**To:** Avi Peretz[avi@water-gen.com]  
**Cc:** Jahne, Michael[Jahne.Michael@epa.gov]  
**From:** Meiners, Greg  
**Sent:** Tue 2/27/2018 6:14:20 PM  
**Subject:** 8MM OD Tubing  
[Quick Connect.jpg](#)  
[Pipe Connect.jpg](#)

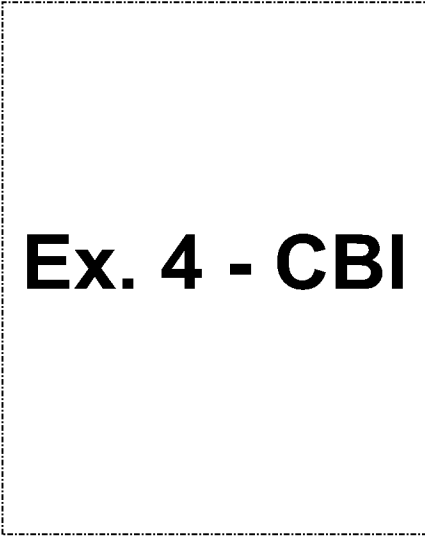
We have a coil of autoclavable 8mm OD tubing for collecting samples at the finish filter quick connect port. It would be easier to install a valve with an 8mm quick connect port on the downstream side. As it is now, water runs on the AWG floor when we pull the plug. Can you get a valve to connect to the tubing fitting or a threaded valve that would screw into the base of the filter? That would be great. Most of our fittings are English and not metric.

See attached photos for reference.
